PSE Current Requirements comments 184, 183 October 2007

**Fred Schindler
Cisco Systems**

Comment 184

Comment 183

Understanding legacy PoE ILIM

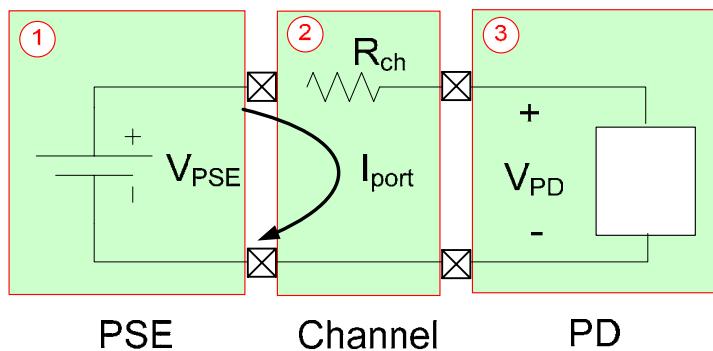
This formula does not produce the correct result!

Recommended Resolution 184

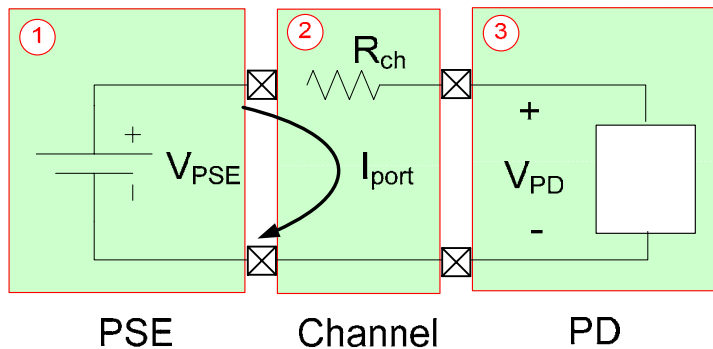
The value of Iport_max created by the formula-using PD Pport_max-does not match the value provided in table 33-12. For example, class 0 PD power is 12.95 W maximum and ~~12.95W/44V = 294 mA~~, not the 400 mA shown in table 33-12, item 4.

- In Table 33-12 item 4, change current to power, and Iport to Pport_peak.

- In section 33.3.5.4 replace “At any operating”, to “For up to 50 ms with 5% duty cycle the current for class 0 – 3, may exceed Pport/Vport or the current for class 4 may exceed Pport/Vport_static. Peak current for any class shall not exceed

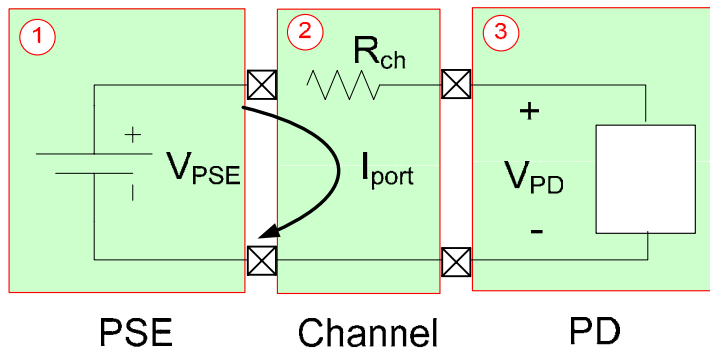
The statements are not clear: is "a" or "b" required?
Option "b" has no time or duty cycle constraint provided. These comments also apply to the new section 33.2.8.4a.

Allow options "a" or "b."
Have one statement for duty cycle and time that applies to both "a" and "b".
